Access Compliance Report

Public Rights-of-Way (Curb Ramps)

Intersection ID: 10033082	Main Street: NORTH_REA_PARK_LN	Cross Street: N/A	Location: NW
ADA ID: F3C48EBB8FCA	Ramp Type: BlendTrans1	Initial Pass/Fail: Pass	Overall Compliance: No Severity Score: 0.25

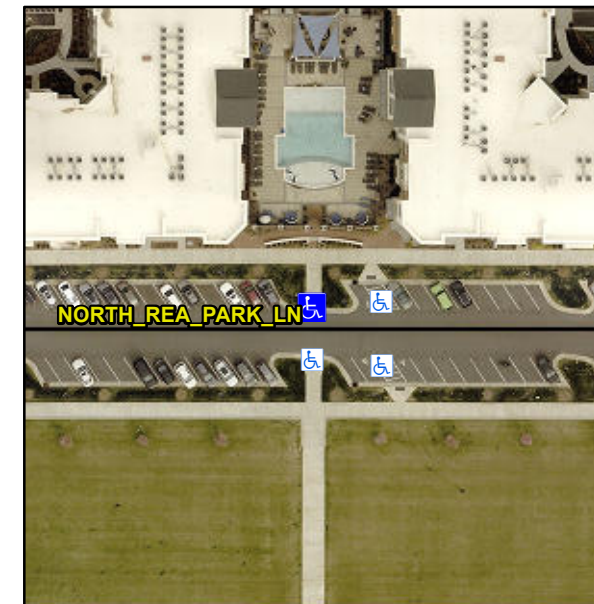
R304.5.3

Compliance	Description	Data	Compliance	Description	Data
N/A	Ramp Length (in)	95.0	Yes	BlendTrans Slope (%)	3.3
Yes	Ramp Width (in)	94.0	No	BlendTrans XSlope (%)	2.5
Yes	Flare Type L	Curbed_NoWalkSurface	Yes	Flare Type R	Curbed_NoWalkSurface
N/A	Flare Slope LT (%)	N/A	N/A	Flare Slope RT (%)	N/A
N/A	Flare Traversable LT?	No	N/A	Flare Traversable RT?	No
Yes	Landing Length (in)	63.0	Yes	DWS Provided?	Yes
Yes	Landing Width (in)	95.5	Yes	DWS Contrast?	Yes
Yes	Landing Slope (%)	1.3	Yes	DWS Length (in)	24.0
Yes	Landing X Slope (%)	1.7	Yes	DWS Full Width?	Yes
N/A	Landing Curb? (Y/N)	No	Yes	DWS Offset (in)	1.0
N/A	Shared Landing?	No			
Yes	Gutter Ponding?	No	Yes	Gutter Slope (%)	3.9
Yes	Gutter Lip Ht (in)	0.0	Yes	Gutter X Slope (%)	1.2
N/A	Painted X Walk1?	No	N/A	Painted X Walk2?	N/A
	X Walk 1 Direction	To S		X Walk 2 Direction	N/A
	X Walk 1 Width (in)	N/A		X Walk 2 Width (in)	N/A
	X Walk 1 Slope (%)	4.0		X Walk 2 Slope (%)	N/A

Remove & Replace Curb Ramp With Two New Directional Ramps or Equivalent.
